### Post Exhibition - Planning Proposal - 2 Chifley Square, Sydney - Sydney Local Environmental Plan 2012 and Sydney Development Control Plan 2012 Amendment

This report details the outcomes of the public consultation of the planning proposal, draft development control plan (DCP) and voluntary planning agreement (VPA) for the site. The documents were exhibited from 22 April to 27 May 2022. 10 submissions were received including submissions from the land owner of the subject site, landowners adjoining and in the vicinity of the site, and public authorities.

Figure 7: Requested change to eastern setback of planning envelope

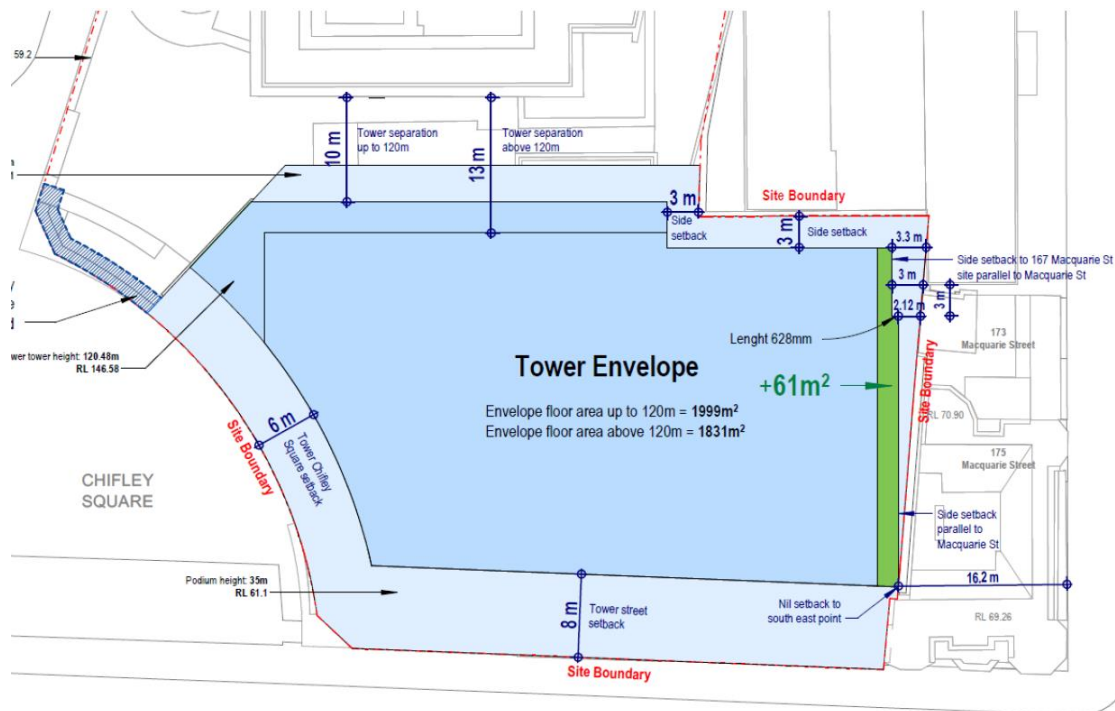
- 42. The proponent, Charter Hall, requested a reduction of the eastern setback of the planning envelope, from 2m - 4.7m to 0m - 3.3m, as shown in the plan at figure 7 below. The change is not supported for the reasons discussed below.
- 43. The additional area of the envelope resulting from the requested reduced setback is depicted in green:

44. The plan shows this reduction in setback would result in an additional 61sqm of floor area, or a total increase 1,026sqm for the whole planning envelope, although this does not factor in building efficiency and articulation allowances.

45. The Central Sydney planning controls allow for setbacks to be reduced subject to there being no overall reduction in amenity (wind and sky view) in public places, and that urban design outcomes are still achieved. The request to reduce the eastern setback was accompanied by sky view factor and wind reports, to demonstrate that the proposed envelope would result in a better outcome in the public domain compared to the base case envelope.

46. Urban design and heritage impacts were a key consideration in the assessment of a suitable planning envelope on this part of the site. In response to concerns raised by the Design Advisory Panel (DAP) about the original proposed envelope, a DAP subcommittee was formed. One of the key issues considered were setbacks, including tower envelope setbacks to the eastern boundary to provide for appropriate building separation, and separation of massing to the two local heritage items at 171-173 and 175-181 Macquarie Street known as 'Horbury House' and 'Wyoming'. The eastern setback of the planning envelope was also established to be sympathetic to the building alignment in Macquarie Street, and provide for a built form to support attractive streetscapes with high amenity. The 2 metre setback was seen as a minimum, as the DAP subcommittee had given consideration to an even greater setback to Macquarie Street for urban design and amenity outcomes.

47. Macquarie Street has important heritage significance, as it includes local, state, and world heritage items, and is included in the Macquarie Street Special Character Area. In addition, the Federal Government has proposed to include the Governors' Domain and Civic Precinct as part of the National Heritage List. This listing is proposed to include Macquarie Street, and Horbury House in particular. Part of the significance of this precinct is the development of Macquarie Street with its early colonial architecture as important milestones in the creation this distinctive civic precinct, with later buildings within the precinct continuing to respect the inherited civic intentions for this area. It is therefore considered that the setback of the planning envelope as exhibited should be retained in order to respect these important heritage considerations.

48. Although the owner of the property at 175-181 Macquarie Street, known as 'Wyoming' provided a submission supporting the reduced setback and advising they would support an easement for maintenance, it is not considered to outweigh the urban design and heritage impacts that would result from a reduced or nil setback from a heritage item.

Figure 9: Comparison of existing and potential view extents westwards from 60 Martin Place, Sydney

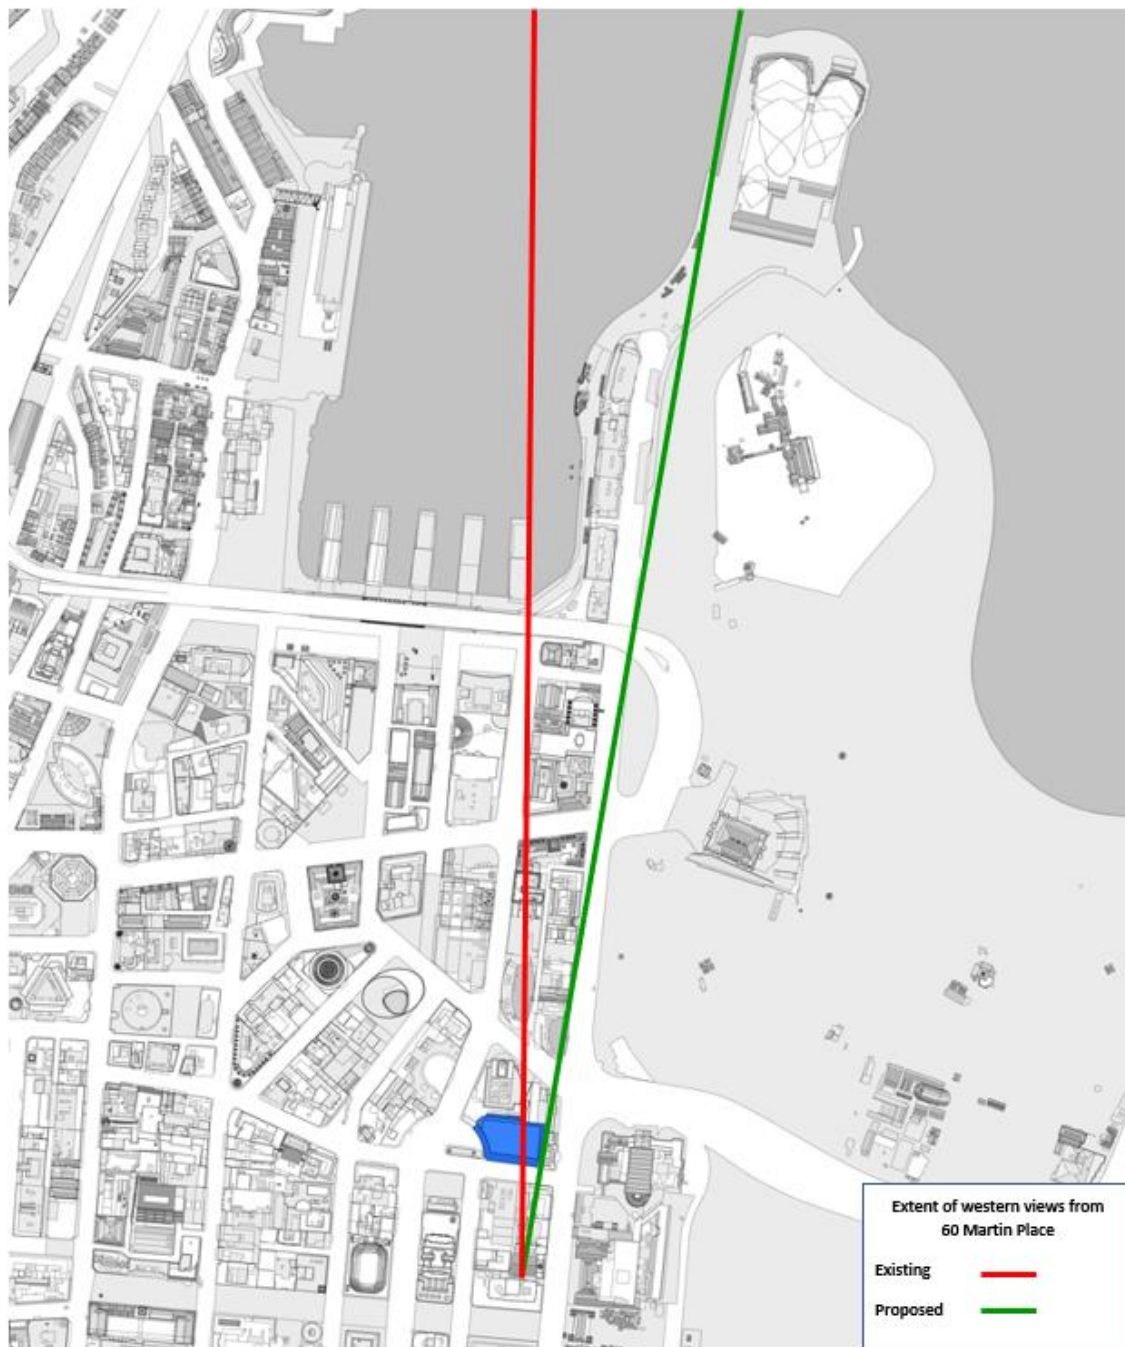
49. A submission was received from the owner of 60 Martin Place raising concerns that the eastern setback of the planning envelope approved by the Central Sydney Planning Committee and Council, of 2m - 4.7m should be increased to comply with the DCP requirement of 6.5m, and have chamfered corners, due to impacts on view loss from 60 Martin Place. The submission included a photo from level 21 of 60 Martin Place, at Figure 8, with the approximate extent of the proposed envelope shown, and potential view loss extent in red hatched area.

50. The Central Sydney Planning Strategy allows for setbacks to be reduced subject to there being no overall reduction in amenity (wind and sky view) in public places, and that urban design outcomes are still achieved. The proposed envelope did not require chamfered corners due to the sky view and wind testing of the envelope resulting in an improvement on the base case envelope, satisfying the requirements of the DCP.

51. The Central Sydney Planning Strategy prioritises views from public places but does not protect views from private places. Protecting private views in Central Sydney would constrain reasonable development that would help achieve the economic objectives for Central Sydney due to the density and heights of buildings.

52. The City's analysis of the existing and potential views from 60 Martin Place is at Figure 9. The existing views in a northerly and westerly direction from the location indicated in the submission are restricted by existing buildings including Chifley Tower, Deutsche Bank Place at 126-144 Phillip Street, and the building at 167 Macquarie Street. Although it is acknowledged that a small portion of existing views would be impacted by the proposed planning envelope, extensive scenic views of the Sydney Opera House, The Domain, the Harbour and distant views eastwards would be retained. The loss of views from 60 Martin Place are not considered to warrant an even greater setback to the eastern boundary than that endorsed by CSPC and Council.
